<b>Project</b>	<b>IEEE 802.16 Broadband Wireless Access Working Group</b> < <a href="http://ieee802.org/16">http://ieee802.org/16</a> >
<b>Title</b>	Editorial changes to .16e in response to comment 108
<b>Date Submitted</b>	2005-09-09
<b>Source(s)</b>	Masoud Olfat (Sprint Nextel), Peiying Zhu (Nortel) Charlie Zhang (Nokia)
<b>Re:</b>	IEEE P802.16e/D10
<b>Abstract</b>	This is a consensus reply comment to .16e in order to fix the
<b>Purpose</b>	Discuss and approve.
<b>Notice</b>	This document has been prepared to assist IEEE 802.16. It is offered as a basis for discussion and is not binding on the contributing individual(s) or organization(s). The material in this document is subject to change in form and content after further study. The contributor(s) reserve(s) the right to add, amend or withdraw material contained herein.
<b>Release</b>	The contributor grants a free, irrevocable license to the IEEE to incorporate material contained in this contribution, and any modifications thereof, in the creation of an IEEE Standards publication; to copyright in the IEEE's name any IEEE Standards publication even though it may include portions of this contribution; and at the IEEE's sole discre

Figure 230a – Post Processing CINR for MIMO Region

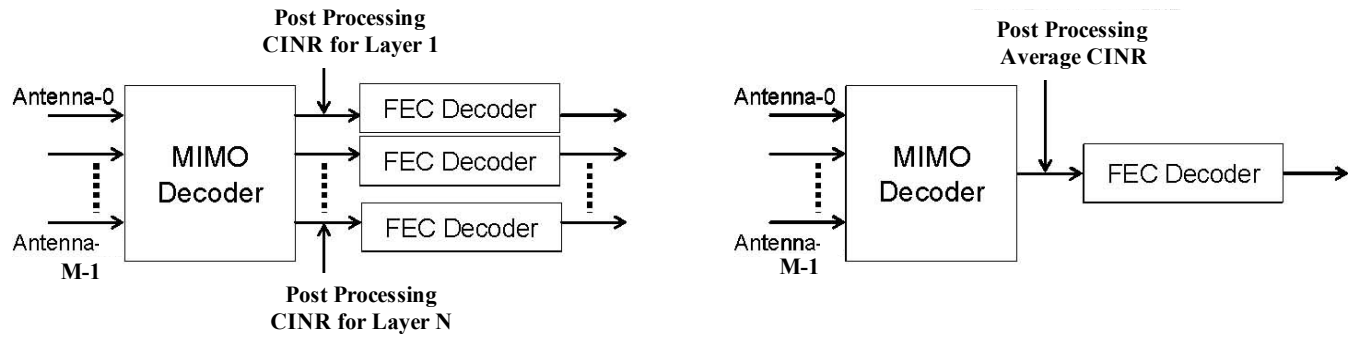
**[Insert following text at the beginning of section 8.4.5.4.10.1]:**

MIMO capable MS shall measure post processing CINR for each individual layers as shown in Figure 230a. When the FAST\_FEEDBACK subheader Feedback Type field is "00", the MS shall report the post processing average CINR (Avg\_CINR), as defined in (106a) below. When BS requests MS feedback through CQICH\_Alloc\_IE() or CQICH\_Enhanced\_Alloc\_IE() with '00' feedback\_type field, MS shall report Avg\_CINR or individual layer CINR as described in 8.4.5.4.12 and 8.4.5.4.16
